NSLPP MEETING HELD ON 09/03/22

ADDRESS/WARD: 153 & 157 Walker Street, North Sydney

PROPOSAL No: 4/21

PROPOSAL: To amend North Sydney Local Environmental Plan 2013 by inserting a site specific clause to permit a 23m height bonus at 153 and 157 Walker Street, if the two properties are redeveloped under a single proposal and meet a number of criteria relating to setbacks delivery of a through site link and sustainability outcomes.

FIGURE 7: Suggested Wind Amelioration Measures

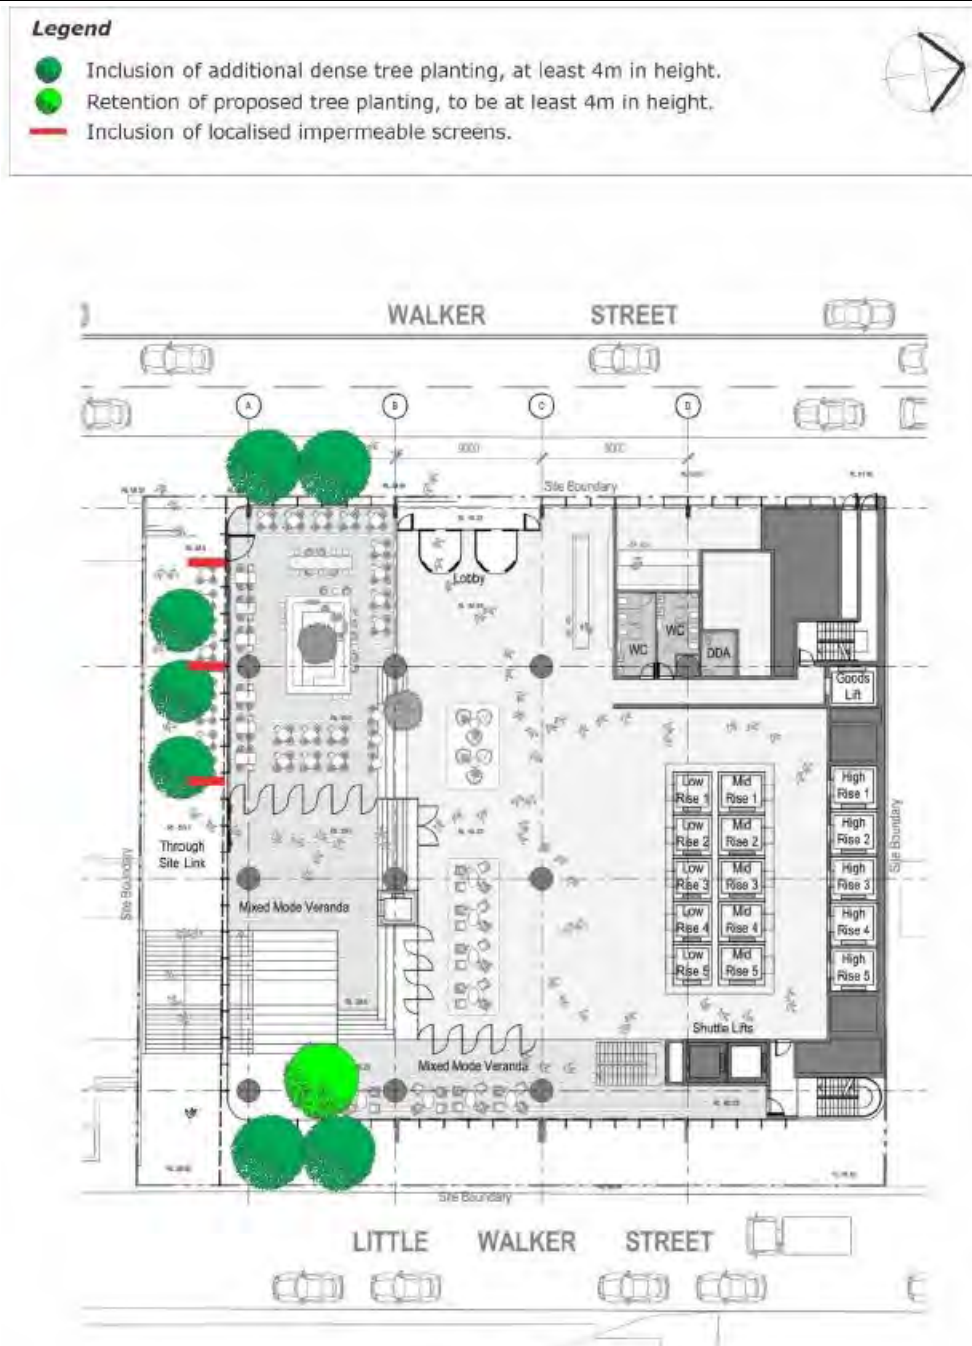
Figure 7 illustrates the types of amelioration measures that could be incorporated at the ground level as identified in the Wind Impact Assessment. These proposed measures would result in delivery of a substandard through site link.

Through site links should remain unobstructed to assist with wayfinding and maximise pedestrian flow. The proposed screens and planting of trees would effectively half the width of the through site link reducing its legibility and capacity as a through site link, undermining its effectiveness.
